## **Able Marine Energy Park**

### *Material Change 2*

**Proposed Able Marine Energy Park Material Change 2**  
**Application ref: TR030006**  
**Applicant's Submissions - 16 March 2022 - document ref TR030006/Cover**

**Able Marine Energy Park 2021 Report DER6453-RT006 R01-00 Modelling of Sediment Plume Dispersion from AMEP Construction Activities**

## Section 5.2

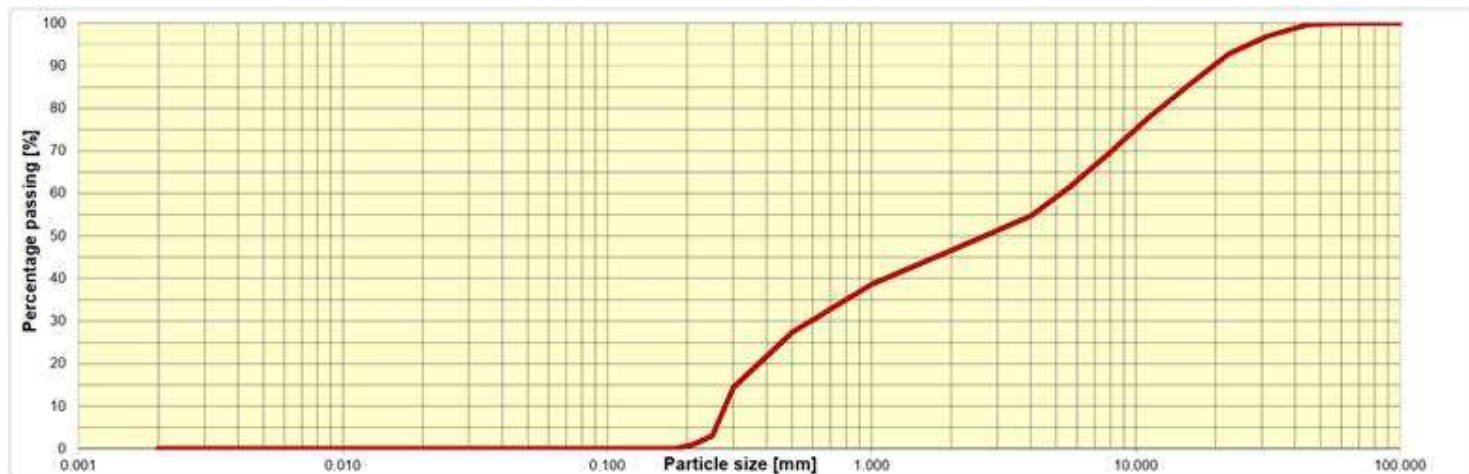
Material from an offshore licensed aggregate site will be used for the reclamation. It is assumed that the fines content in the fill material will be 1% when pumped ashore. There is no specific information (such as particle size analysis data) regarding the nature of the sediment that will be pumped ashore. This should be included in order to show whether this offshore aggregate will alter the sedimentary character of the seabed at and around the reclamation site. This will help to validate the model results.

The plume modelling has focussed on the release of the finest fraction of material from the run-off (see response above). The coarser material from the placement will either remain in the footprint of the reclamation as part of the permanent works or will be redistributed locally and then be dredged in subsequent phases of the works.

The fines content of material in-situ at licensed offshore aggregate sites is generally very low (a few percent or less). After being dredged by TSHD at the aggregate site with some overflow during the loading of the dredger the fines content will be further reduced. Our assumption of 1% fines in the material being placed ashore into the reclamation is considered conservative. An indicative grading curve is provided below.
